TECHNICAL EVALUATION REPORT

MASONRY WALL DESIGN (B-59)

BROWNS FERRY NUCLEAR PLANT UNITS 1, 2, AND 3

September 26, 1983

SKETCHES OF WALL MODIFICATIONS

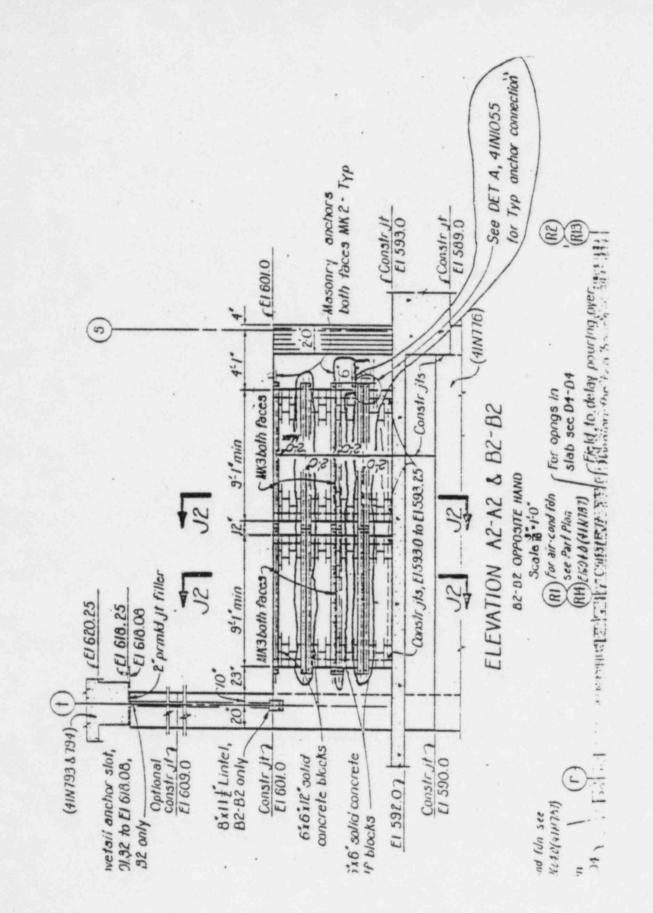
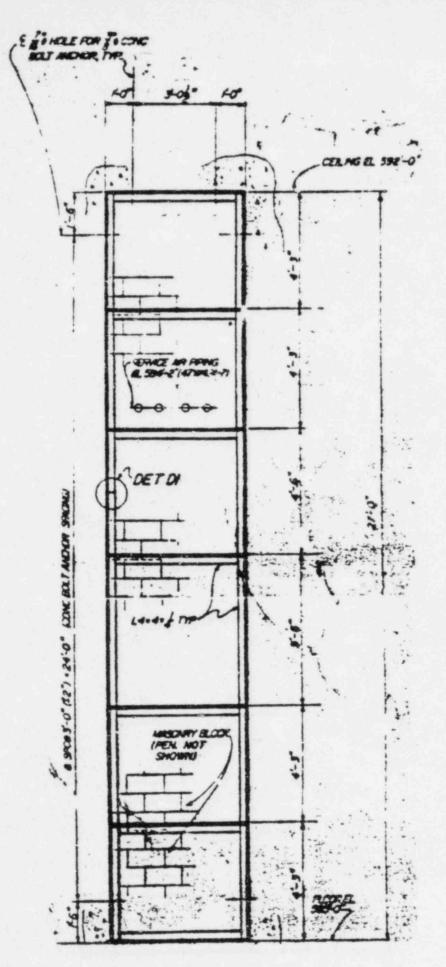
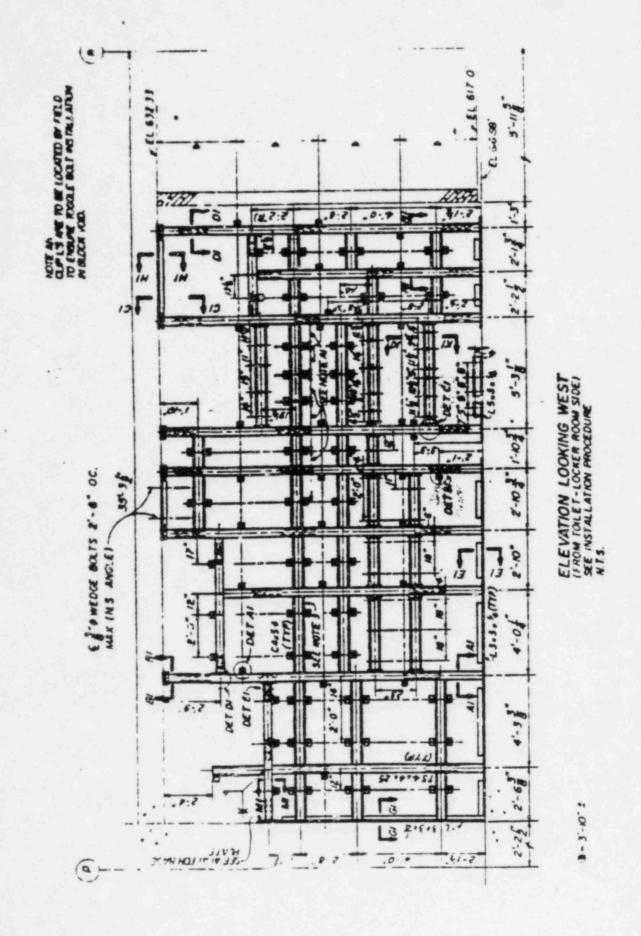
The Licensee also provided detailed drawings of sample modifications which consist of a grid system with channel steel members in the horizontal direction, and tube steel members on the vertical directions, or angle steel members in both horizontal and vertical directions (see pages B.2 and B.3, Attachment B).

Sample calculations also were provided to show the adequacy of the wall modifications. For wall 71C, vertical steel angles were provided at the edges of the wall and were anchored to the concrete column on both sides of the wall. Horizontal steel angles were also provided and welded to the vertical angle structural members.

The Licensee has identified 19 of the 71 safety-related masonry walls at Browns Ferry Units 1, 2, and 3 as being modified. Two walls have already been fixed (24 and 92). There are three walls in which a shield will be designed to protect the safety-related items (71D, 71E, and 71F). The remaining 14 walls (both mortared and unmortared) will have the following design fixes. (Sketches are provided in Appendix B.)

- 1. Use a structural steel grid system to contain the wall in the event of failure (mortared walls 5B, 5C, 5D, 71B, and 71C).
- Use horizontal structural steel restraints at a spacing determined by 10-psi allowable tensile stress in the mortar (mortared walls 6, 72, and 105).
- 3. Use horizontal structural steel restraints (see Response 6 for more details) at a spacing determined to limit moment and shear (by use of a stability analysis for blocks between restraints) so that the blocks will not fall [unmortared walls 15, 20, 52, 60, 83, and 87. All six walls are 8 ft high and 2 ft thick (4 wythes); their restraints spacing is 2 ft; and all are located at the same floor level, elevation 593 ft.].

The modification methods and sample calculations have been reviewed and judged to be adequate and in compliance with the SGEB criteria. Further discussion on modified walls is given in the next section (Section 3.2).

Review of the drawings and sample calculations finds the modifications to be adequate and satisfactory and the modified walls are in compliance with the SGEB criteria.
